Catherine Creek Loop Trail Bridge

Consistency Determination (CD-26-02-S)

Catherine Creek Loop Trail Bridge, CD-26-02-S

Parcel/Tax Lot #03112500000101, Klickitat County, Washington

Project Site Plan

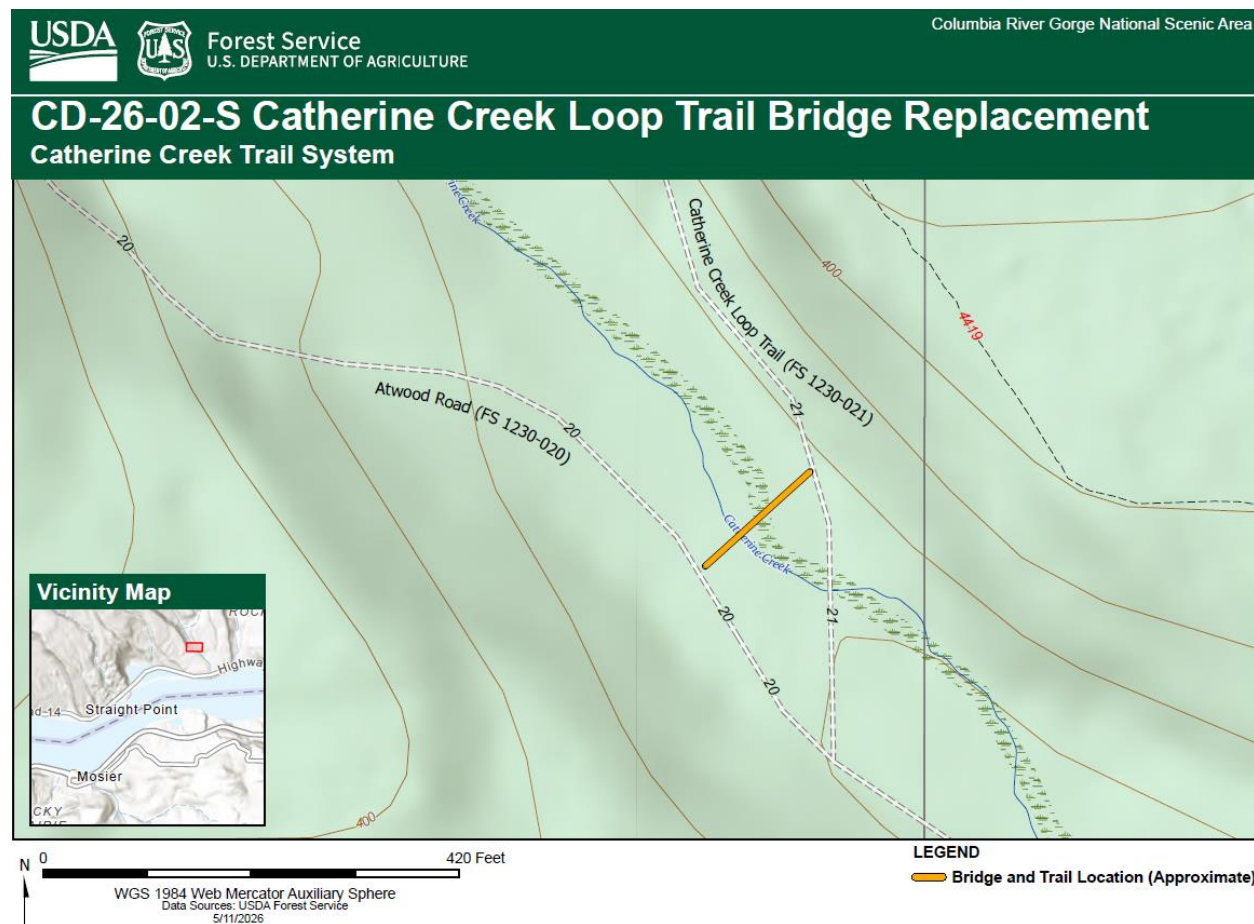
Comment: Stefanie Berge, Wildlife Biologist with the Washington Department of Fish and Wildlife, stated that the project was occurring within California mountain kingsnake habitat, which is a candidate for Washington State listing and protection. She requested that work occur outside the May to August nesting season, and preferably in December to February when the snakes hibernate. Stefanie recommended three project design criteria:

- *In areas where vegetation/debris or rocks/crevices are to be removed (areas of cover), someone shall clear those areas (survey and check for snakes) immediately prior to grading/removal of the habitat.*
- *If underground refugia is present (under rocks, burrows, or crevices), someone other than the equipment operator shall watch during the initial grading and stop equipment to move snakes out of the way, if any are seen.*

- *Once all refugia is cleared, no one should be needed to monitor work, but equipment operators should be aware and maybe check around and under anything left on-site overnight (including trucks/dozers) to make sure no snakes are present. If any are found either avoid the area until they leave on their own, or have someone move the snake out of the work area.*

Comment: Steve McCoy, Staff Attorney for Friends of the Columbia River Gorge, stated the applicable guidelines from the Management Plan for review. Steve also included specific comments regarding visibility from Key Viewing Areas, cumulative effects to scenic resources, and the presence of sensitive plants and wildlife in the area.

Response: Review of potential effects to California mountain kingsnake is included in the Natural Resources section of the Consistency Determination.

Response: Review of potential effects to all resources, including scenic resources and sensitive plants and wildlife, is included below.
